METROPOLITAN GOVERNMENT OF NASHVILLE AND DAVIDSON COUNTY

STAFF RECOMMENDATION
2001 Russell Street
April 16, 2014

Application: Demolition—outbuilding; New construction—detached accessory dwelling unit

Description of Project: The applicant proposes to build a Detached Accessory Dwelling Unit (DADU) at the rear of the property, behind a historic house.

Figure 2. The outbuilding to be demolished.

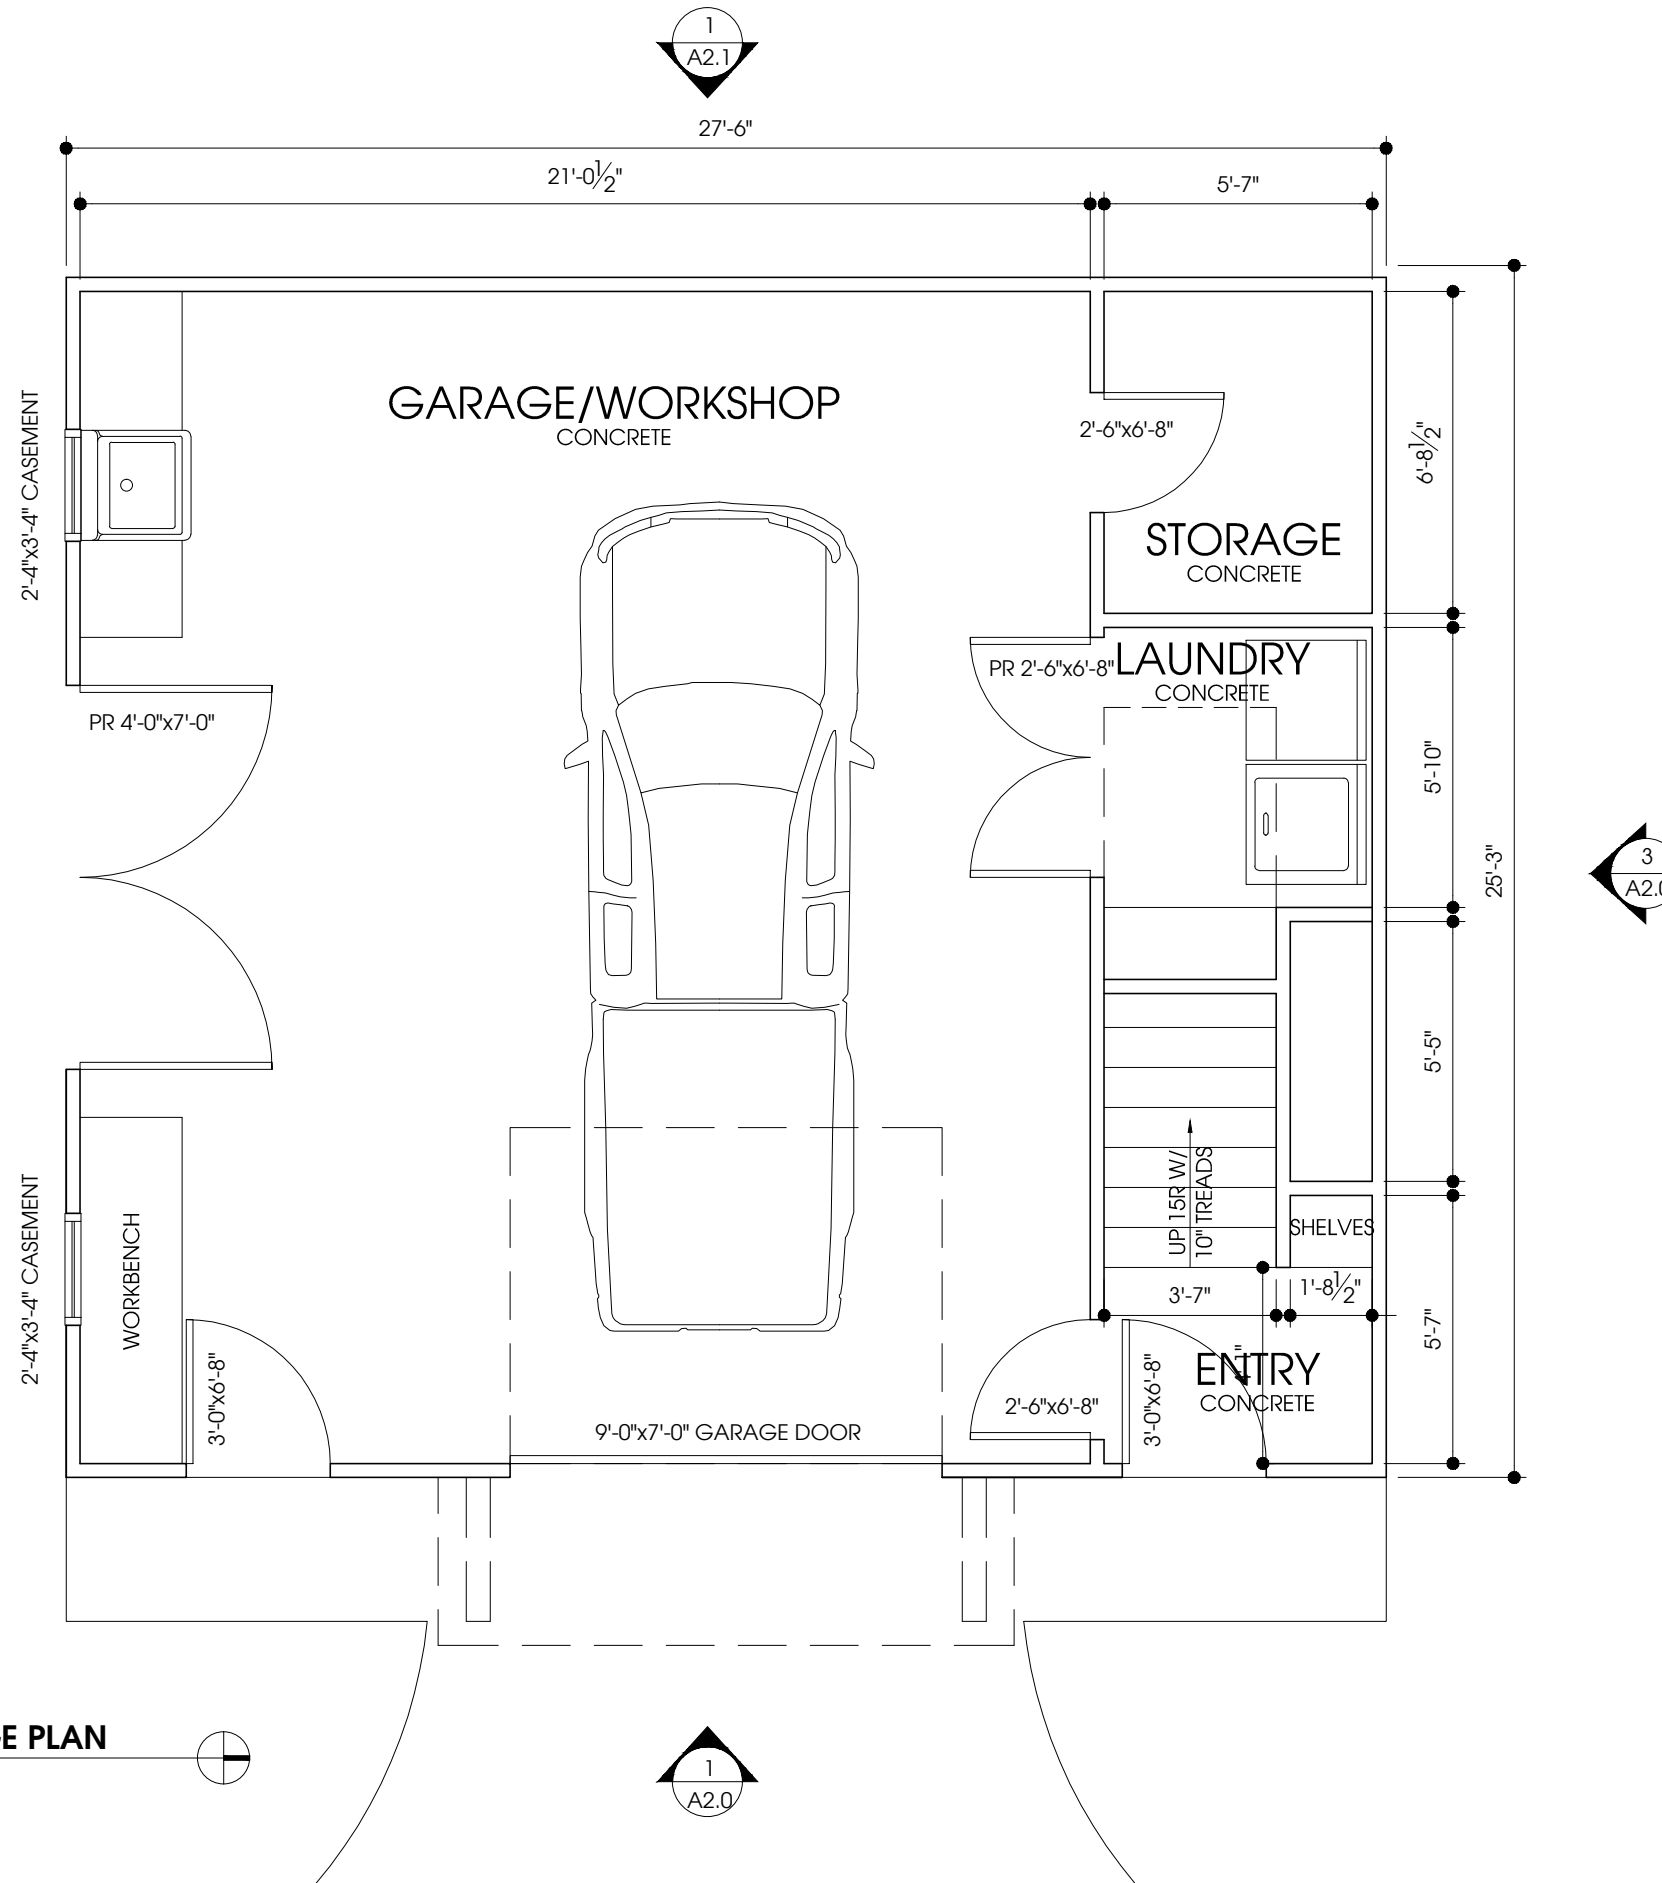
Demolition: As part of the application, the applicant is proposing to demolish a non-contributing accessory structure (Figure 2). Staff finds that the accessory structure lacks historic and architectural interest, and that it does not contribute to the historic character of the site or of the historic Lockeland Springs neighborhoods. Staff therefore finds that its demolition meets Section IV.B.2. and does not meet Section IV.B.1. of the design guidelines.

3 REAR (NORTH) ELEVATION

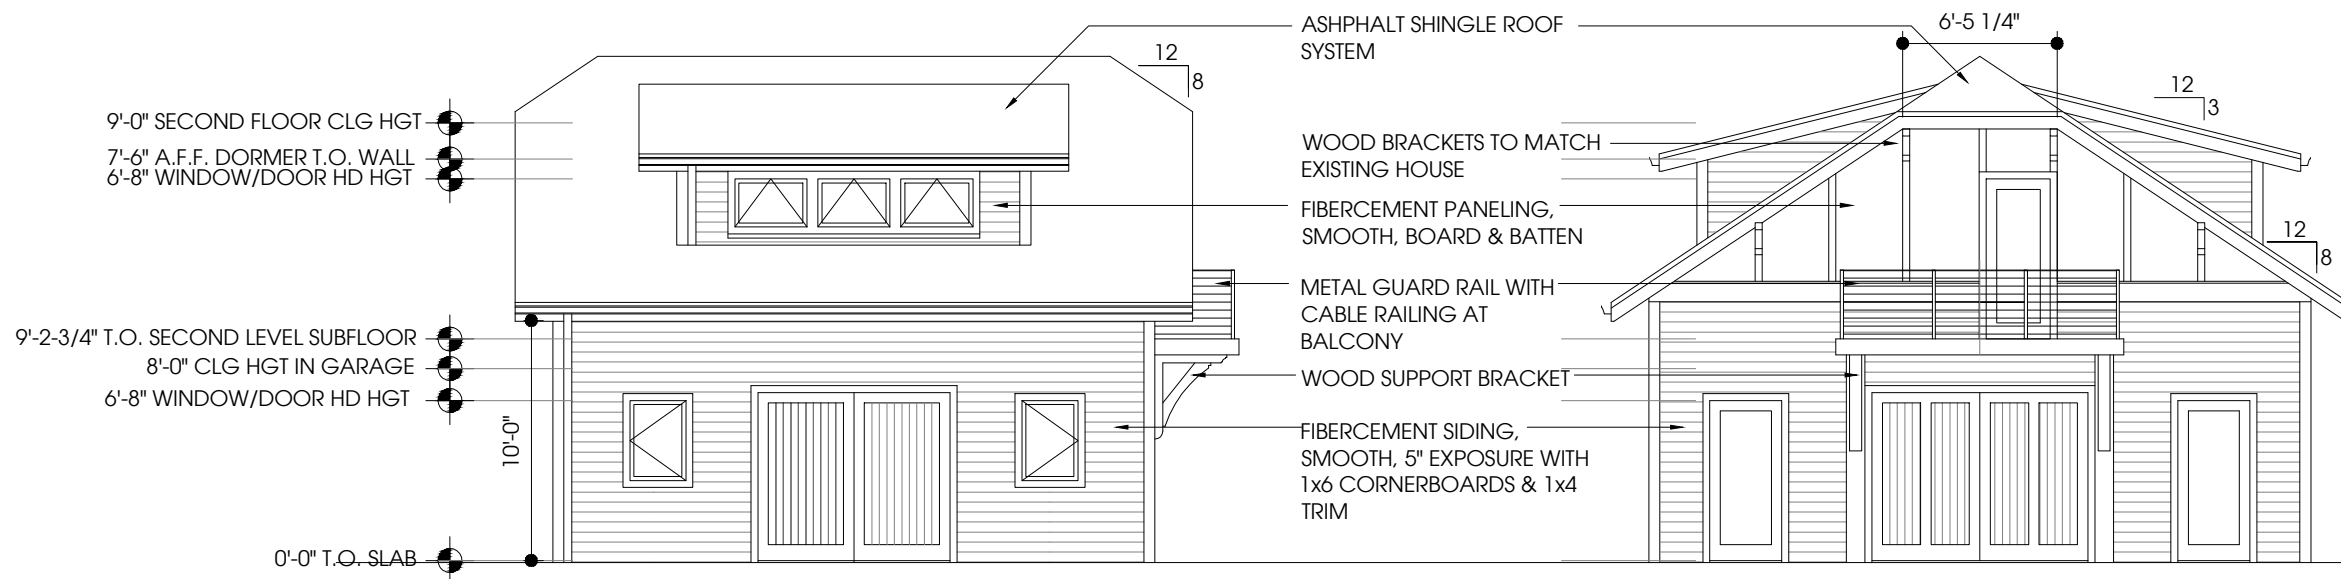
Bulk and Massing. The accessory structure is one-and-a-half stories tall. Its footprint is approximately six hundred and ninety-four square feet (694 sq. ft), less than the maximum footprint of seven hundred square feet (700 sq. ft.) for one-story structures. The ridge height is approximately twenty-one feet (21') from grade and the eave height is

ten feet (10'). These are both subordinate to the historic house, which has an eave height of eleven feet (11') and a ridge height of twenty-four feet (24'). The structure meets Standard 7 of the Detached Accessory Dwelling Unit regulations.

Design Standards. The outbuilding's design is compatible with the style of the historic structure. Its roof, detailing, and overall form do not contrast greatly with the primary structure. The structure's stairs are located on the interior. Its roof form includes shed dormers on the north and south elevations. The dormers sit back two feet (2') from the wall below them, and they occupy less than fifty percent (50%) of the roof. The fenestration pattern is appropriate for an outbuilding, and the structure is in a minimally-visible location at the rear of the historic structure. The proposed outbuilding therefore meets Standard 8 of the Detached Accessory Dwelling Unit regulations and II.B.1.8. of the design guidelines.

Roof form: The outbuilding will have a side-gabled roof with clipped gables, matching the roof form of the historic house. The gable will have a pitch of 8/12. The shed dormers will have a pitch of 3/12. Staff finds that the outbuilding's roof form meets section II.B.8. of the design guidelines.
